MWO 9-2350-267-20-3

## MODIFICATION WORK ORDER

**M992 FIELD ARTILLERY AMMUNITION SUPPORT VEHICLE (FAASV)  
HEATER SWITCH GUARD**

15 August 1991

Figure 1

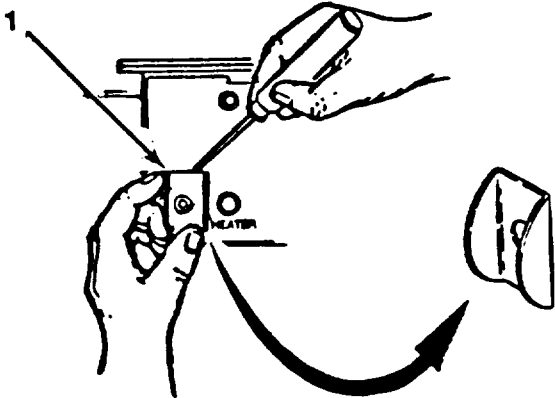
- a. Remove nut and lock-washer from heat selector switch of heater control box (located in driver's compartment).
- b. Place switch guard (1) over switch. Using switch guard as a template, scribe a line onto plastic face plate along the top and right side of switch guard as shown (see Figure 1).

Figure 2

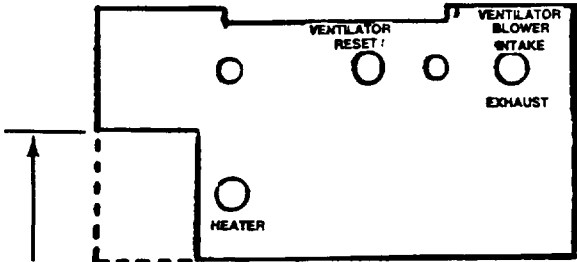
- d. Remove face plate.
- e. Using a straight edge, continue scribing lines to edge of plate. Cutout corner as shown (see Figure 2).
- f. Replace face plate.

NOTE  
This is area  
to be cut out

Figure 3

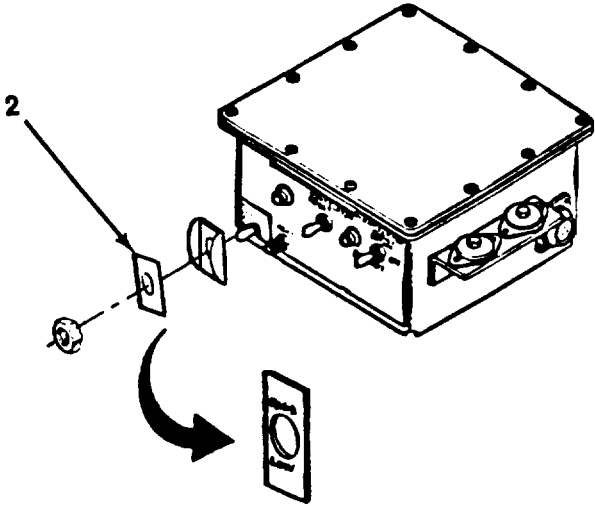
- g. Lay switch guard label (2) over heat selector switch. Insure keyway is mated with switch. Peel backing and stick switch guard label over switch and fasten to switch with nut and lock-washer (see Figure 3).
